DESIGN <i>KE</i>	DRAWN BY <i>KE</i>	DART AEROSPACE USA, INC. FAIRCHILD INTERNATIONAL AIRPORT, WA	
CHECKED <i>CP</i>	APPROVED <i>KE</i>	DRAWING NO. DEO 9145	REV. A SHEET 1 OF 1
DATE 99.03.09		TITLE 206/407 STEP LUG CHANGES	SCALE 2:3
A	99.03.09	NEW ISSUE (TSR A899)

DART ENGINEERING ORDER

TO AMEND PARTS D2731-1/-3/-5/-7
ON DRAWING D2731 REV. A

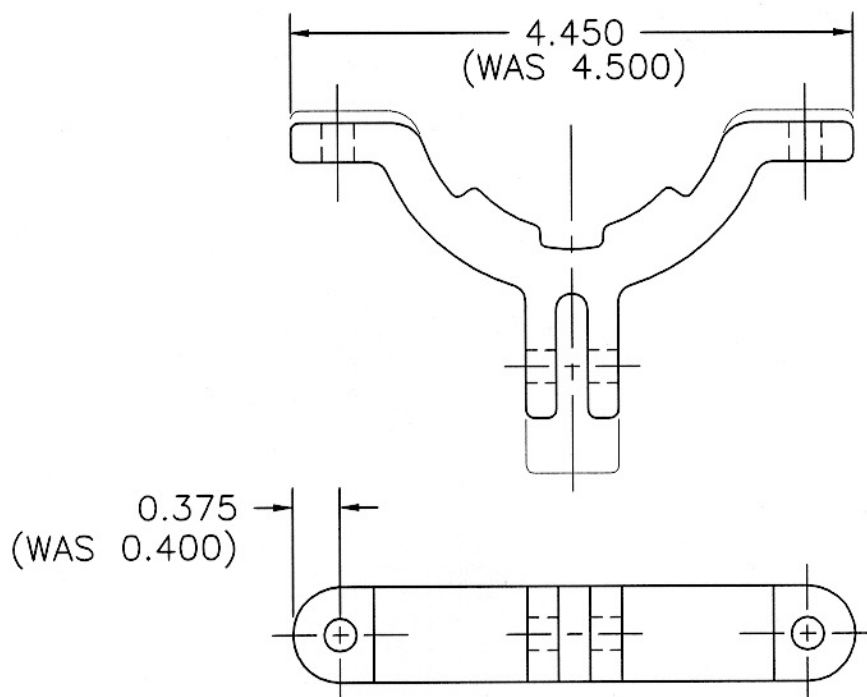
1) CHANGE THE FOLLOWING DIMENSIONS:

2) CHANGE FINISH FROM:
POWDER COAT WHITE (4.3.5.1) PER DART QSI 005 4.3
TO:
ACID ETCH AND ALODINE PER DART QSI 005 4.1
POWDER COAT WHITE (4.3.5.1) PER DART QSI 005 4.3
